**CITY OF SACRAMENTO
DEPARTMENT OF PLANNING & BUILDING
ZONING ADMINISTRATOR
915 I Street, Sacramento, CA 95814**

ACTION OF THE ZONING ADMINISTRATOR

On Thursday, October 6, 2005, the Zoning Administrator approved with conditions a special permit modification to rebuild a McDonalds fast food restaurant drive-through on a 35,620 square foot parcel in the General Commercial (C-2) zone for the project known as (File Z05-174). Findings of Fact and conditions of approval for the project are listed on pages 4-8.

Location: 5525 Folsom Boulevard (D3, Area 1)

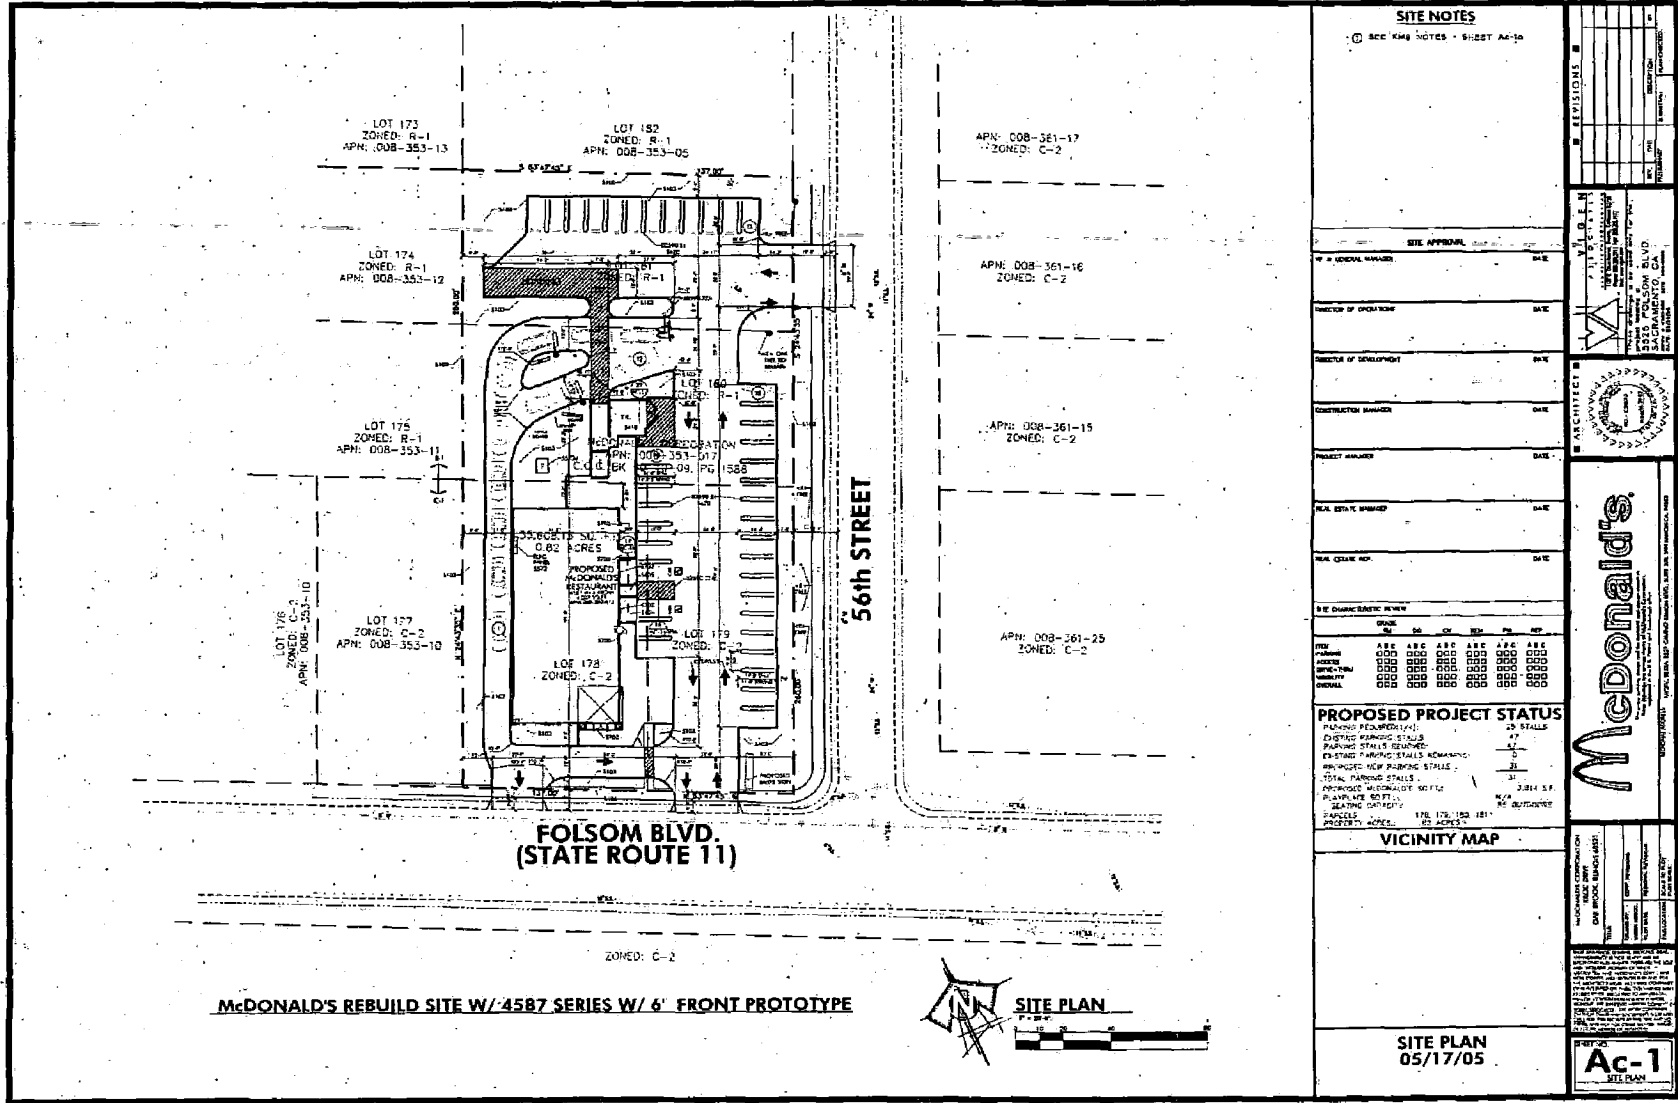
3. All mechanical equipment shall be screened to prevent visibility from the street.
4. The on-site Folsom Boulevard driveway proposed within the front setback that connects the drive-through lane exit to the parking lot shall be removed and replaced with landscaping and a useable patio area for outdoor seating.

5. A pedestrian walkway between the Folsom Boulevard sidewalk and the patio area is to be provided. Use of landscaping and/or decorative trellis to provide effective shading of the patio area is requested. Final exterior layout and decorative elements of the patio area shall be reviewed and approved by staff. (see Sally Shore 808-8001)

18. The site plan shall conform to the parking requirements set forth in chapter 17 of City Code (Zoning Ordinance);
19. The western most driveway to the site on Folsom Boulevard (drive-thru outlet) shall be restricted to exit only. The applicant shall provide all necessary signing and striping to comply with this condition to the satisfaction of the Development Engineering and Finance Division;

21. The eastern most driveway along Folsom Boulevard shall function as a two way driveway. However, the driveway shall have a restricted movement of right-in/right-out only. The applicant shall provide any needed signage and striping to accommodate this condition to the satisfaction of the Development Engineering and Finance Division;

A-2A
 REVISIONS

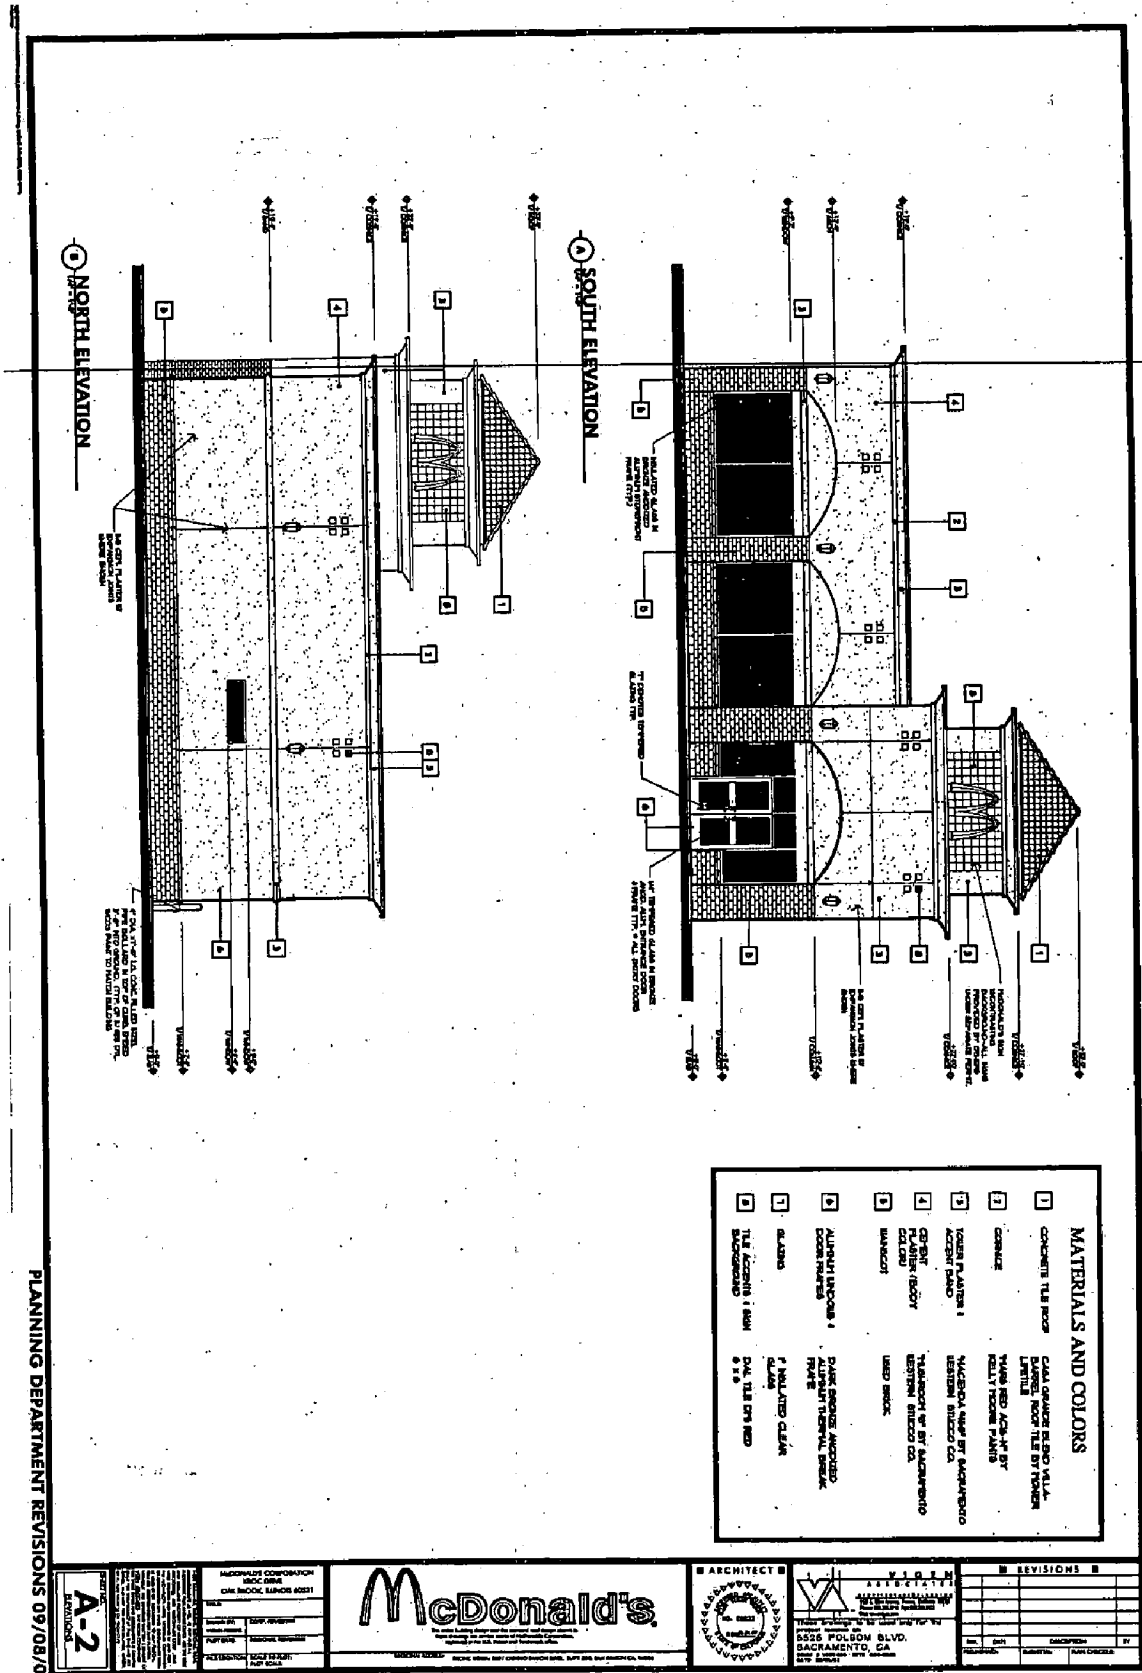
PLANNING DEPARTMENT REVISIONS 09/08/05
